ADDENDUM NO. ONE (1)
CITY OF STATHAM, GEORGIA
OAK STREET SPRING IMPROVEMENTS
ISSUED March 27, 2026

RE: OAK STREET SPRING IMPROVEMENTS
EMI PROJECT No. 24-012

This Addendum forms a part of the Contract Documents and Drawings and modifies the original bidding documents dated FEBRUARY 2026.

C2

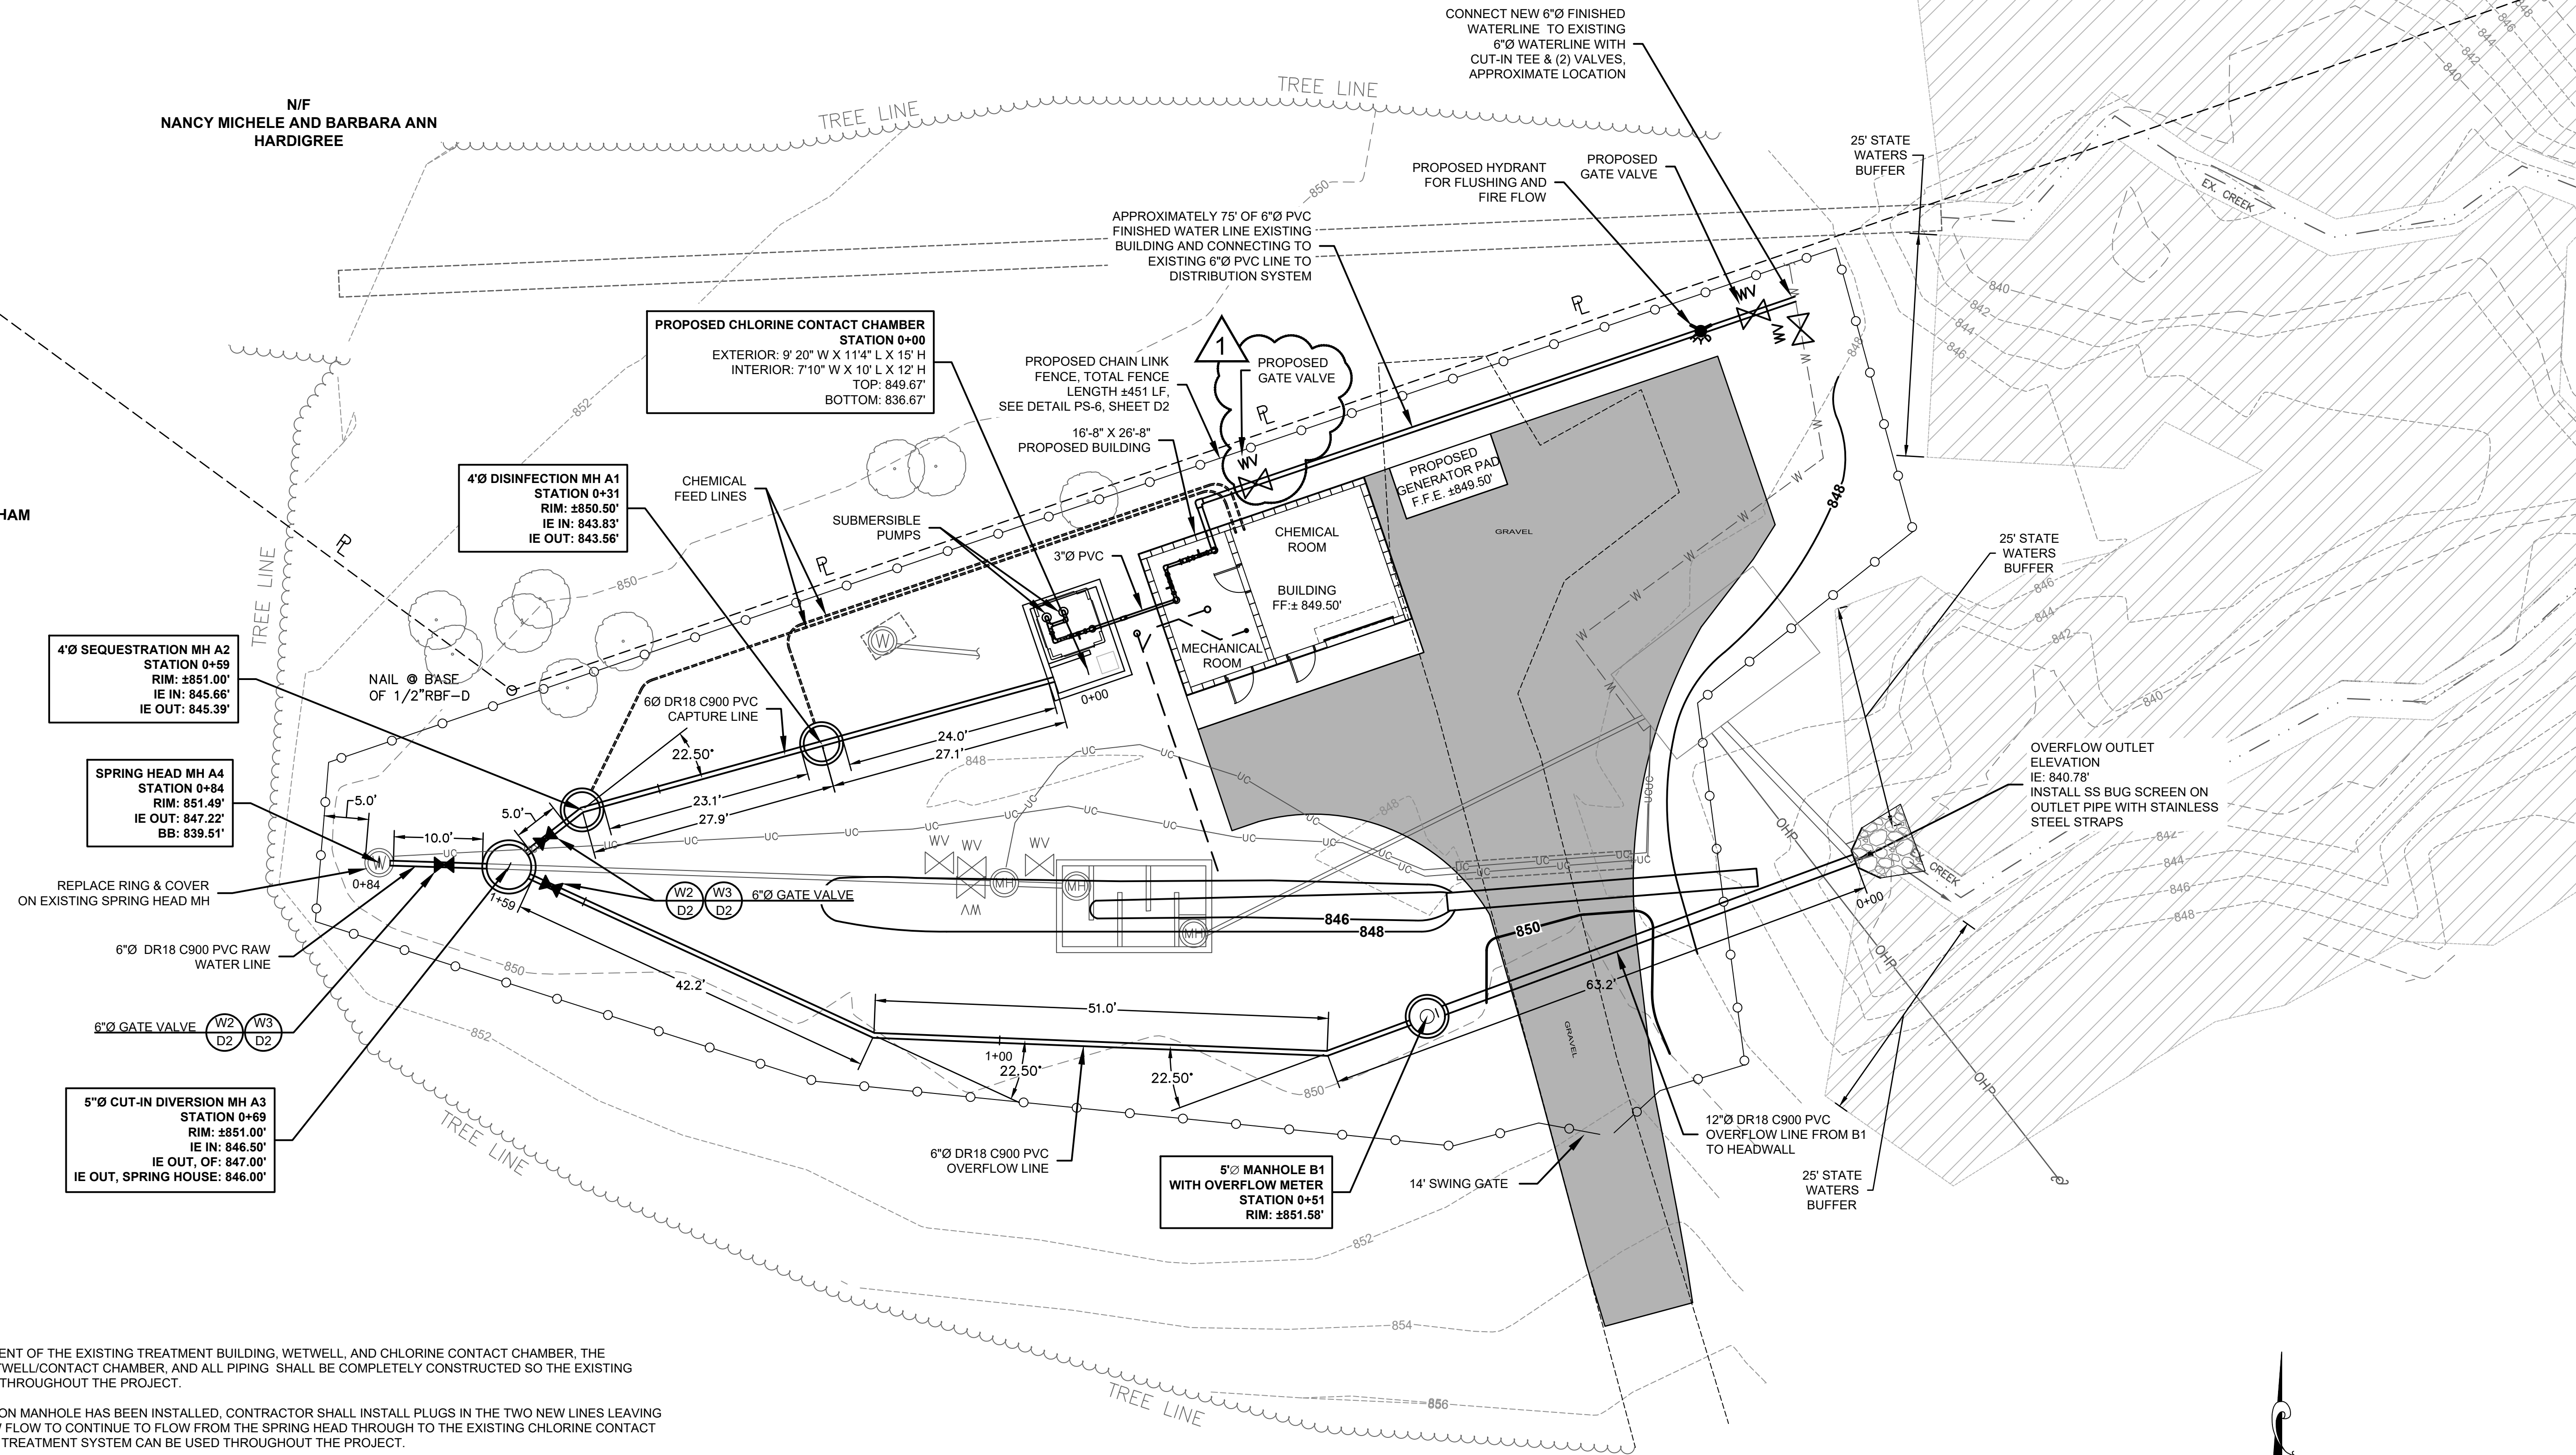
- Plan Sheet C2 has been revised as follows. See attached revised plan sheet. (revisions are shown with revision clouds)
 - **A callout has been added for the removal and disposal of the existing CMP storm pipe.**

SHEET
 C3

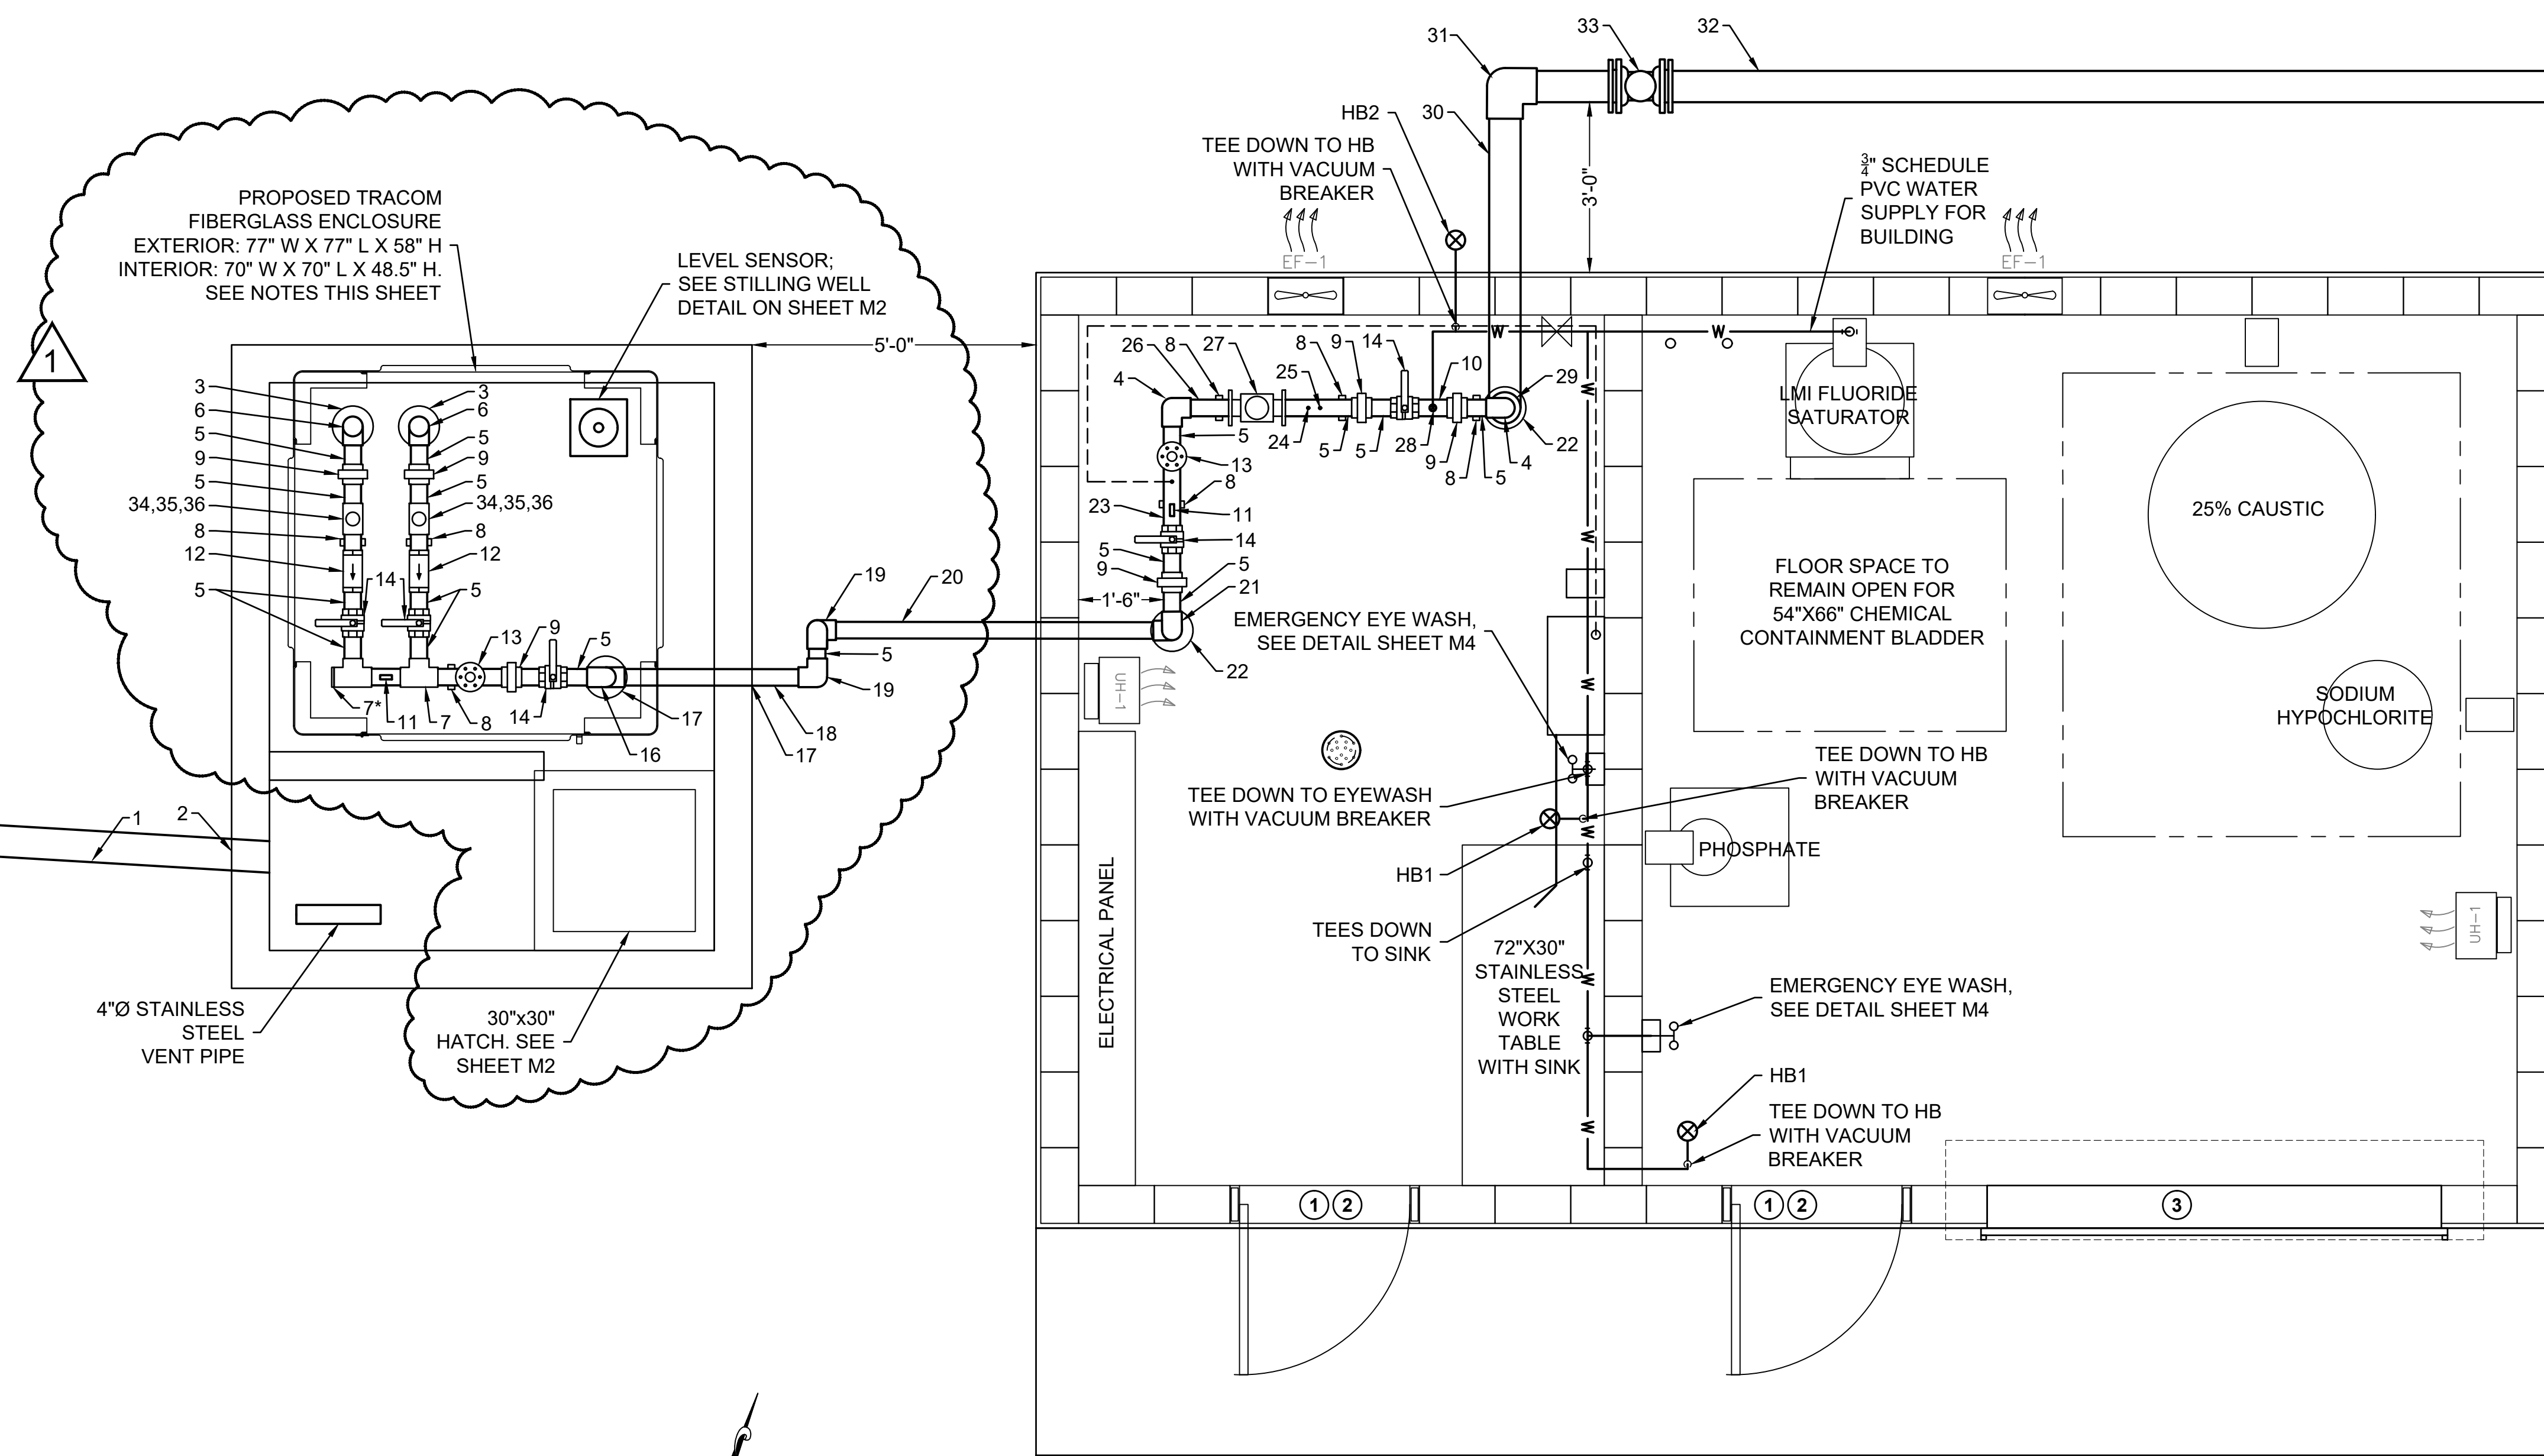
- Plan Sheet C3 has been revised as follows. See attached revised plan sheet. (revisions are shown with revision clouds)
 - **A gate valve has been added to the 6" finished water line outside of the building.**

3. CONTRACTOR SHALL ALSO INSTALL THE TEE AND GATE VALVES CONNECTING THE PROPOSED 6" FINISHED WATERLINE TO THE EXISTING WATERLINE. THE VALVE ON THE EXISTING WATERLINE SHALL BE OPENED AND THE VALVE ON THE PROPOSED WATERLINE FROM THE NEW BUILDING SHALL BE CLOSED.
